#### **DEVELOPMENT REVIEW APPLICATION**

I, Mc lanc Etheredename), employee of SAFStor (entral, (company), authorize Jake Hughes as an approved agent to resubmit the revised landscaping plan for SAFStor Central, BP-2022-22506.

**RE:** SafeStor Self-Storage

**Lot 1 Block 3 Town of Atrisco Grant Conceptual Grading and Drainage Plan**

SHEET # LS-101

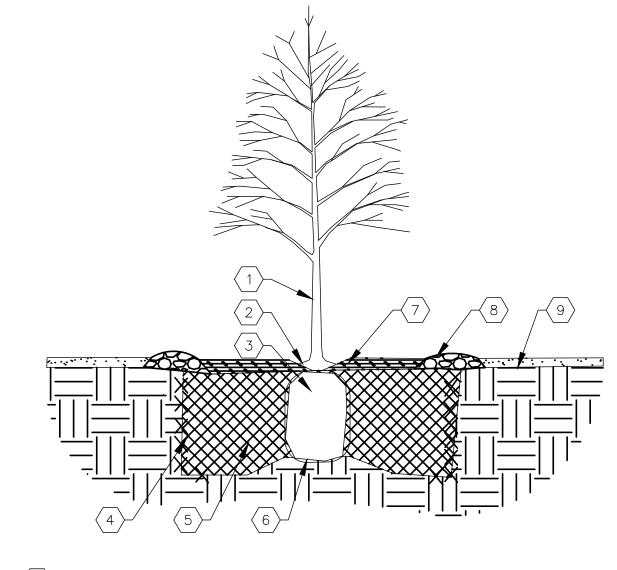
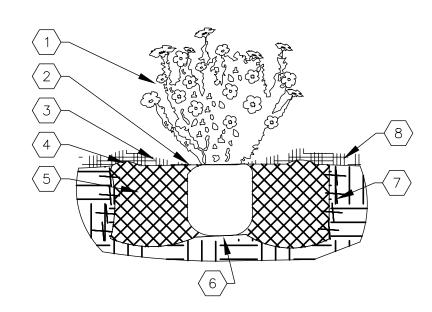
The attached landscape plan has been modified from its original use to better benefit the owner regarding landscape efficiency and overall cost. Per IDO Section 14-16-5-6(C)(16), this landscape plan still meets the following requirements of a visually attractive, sustainable desert landscape:

Overall, the proposed landscape plan still meets all requirements of local and city jurisdictions and still provides significantly more landscape coverage than required, using all applicable plants, shrubs, trees, etc. relative to the local requirements. This is simply a reduction in overall shrub count.

SYMB.	~~OIY	~~	TYPE
	36255	SF	Landscape Gravel A with Filter Fabric  34" Crushed Grey Gravel
	5322	SF	versize Landscape Gravel / No Filter Fabric 2-4" Angular Cobble/RipRap
	480	SF	Native Seed Area
1 // 2		لداد	Reduced landscape quantities.
